SERVICE INSTRUCTION

Service Instruction No. 1514C
(Supersedes Service Instruction No. 1514B)
Engineering Aspects are
FAA Approved

SUBJECT: Roller Tappets Part Information Update

Figure 1
Roller Tappet Assemblies

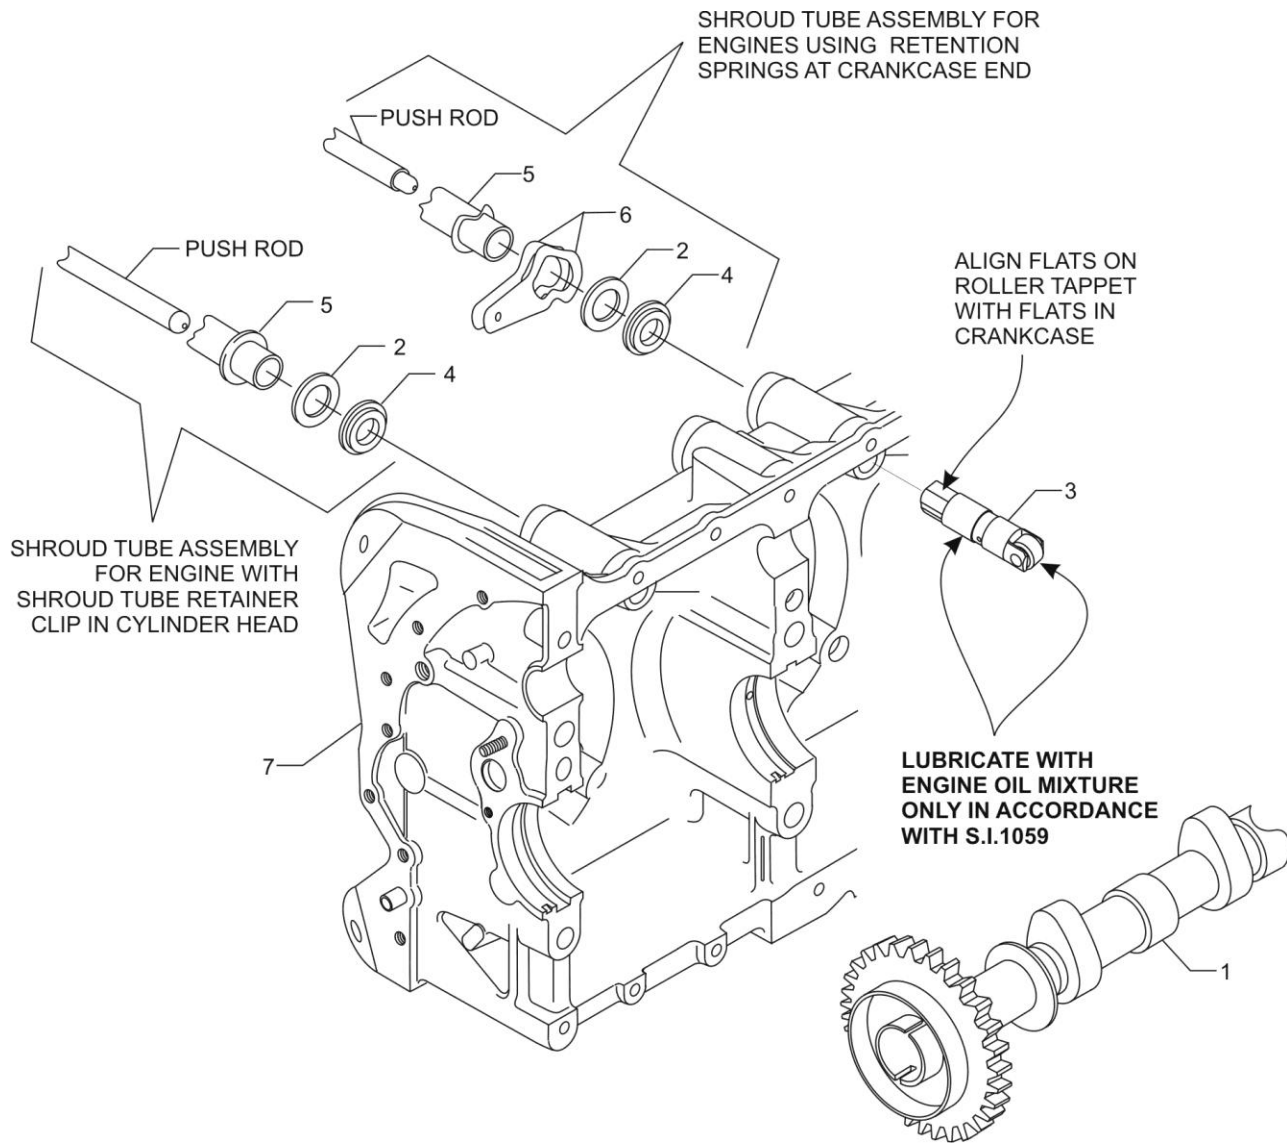
Following is a list of the parts, roller tappet part numbers and flat tappet part numbers for four-cylinder aircraft engines. (Refer to illustration.)

Following is a list of the parts, roller tappet part numbers and flat tappet part numbers for six-cylinder aircraft engines. (Refer to illustration.)

Item No.	Current Flat Tappet P/N	New Superseding Roller Tappet P/N	Description
1	LW-18840	15M23452	Camshaft Assy.
1	LW-18845	15M23454	Camshaft Assy. (Left-Hand Engine Rotation)
1	LW-18843	15M23456	Camshaft Assy.
1	15M19407	15M23496	Camshaft Assy. (Left-Hand Engine Rotation)
2	66728	01L23459	Washer, .78 ID x 1-3/8 OD x .041
3	72877	LRT23381	Body Assy., Hydraulic Tappet Roller
4	LW-18661	06A23493	Seal, Shroud Tube
5	LW-11485	15G23461	Shroud Tube
5	72255	15G23462	Shroud Tube
5	68987	15G23494	Shroud Tube
6	LW-13077	15H21201	Spring, Shroud Tube
7	LW-13823-1	LW-13823-5	Crankcase Assy.
7	LW-18399-1	LW-18399-5	Crankcase Assy.
7	LW-18402-2	LW-18402-5	Crankcase Assy.
7	LW-18770-1	LW-18770-5	Crankcase Assy.
7	11B19524-1	11B19524-5	Crankcase Assy.
7	11B20061-1SL	11B20161-1SL	Crankcase Assy.
7	11B20061-1SH	11B20161-1SH	Crankcase Assy.
7	11B20061-1SB	11B20161-1SB	Crankcase Assy.
7	11B20061-1DL	11B20161-1DL	Crankcase Assy.

Item No.	Current Flat Tappet P/N	New Superseding Roller Tappet P/N	Description
1	LW-19340	15N23374	Camshaft Assy.
1	-----	15N26092	Camshaft - No Tach Shaft (Roller Lifter)
2	66728	01L23459	Washer, .78 ID x 1-3/8 OD x .041
3	72877	LRT23381	Body Assy., Hydraulic Tappet Roller
4	LW-18661	06A23493	Seal, Shroud Tube
5	LW-11485	15G23461	Shroud Tube
5	LW-18944	15G23487	Shroud Tube
5	72255	15G23462	Shroud Tube
5	72257	15G23948	Shroud Tube
6	LW-13077	15H21201	Spring, Shroud Tube
7	11E24000-D1	11E24100-D1	Crankcase Assy.
7	11E24000-D2	11E24100-D2	Crankcase Assy.
7	11E24000-S1	11E24100-S1	Crankcase Assy.
7	11E24000-S3	11E24100-S3	Crankcase Assy.
7	11E24000-S4	11E24100-S4	Crankcase Assy.
7	11E24001-S1	11E24101-S1	Crankcase Assy.
7	11E24001-S4	11E24101-S4	Crankcase Assy.
7	11E24002-D3	11E24102-D3	Crankcase Assy.
7	11E24005-S1	11E24105-S1	Crankcase Assy.
7	-----	11E24106-S1 ▲	Crankcase Assy.
7	11F24020-D1	11F24120-D1	Crankcase Assy.
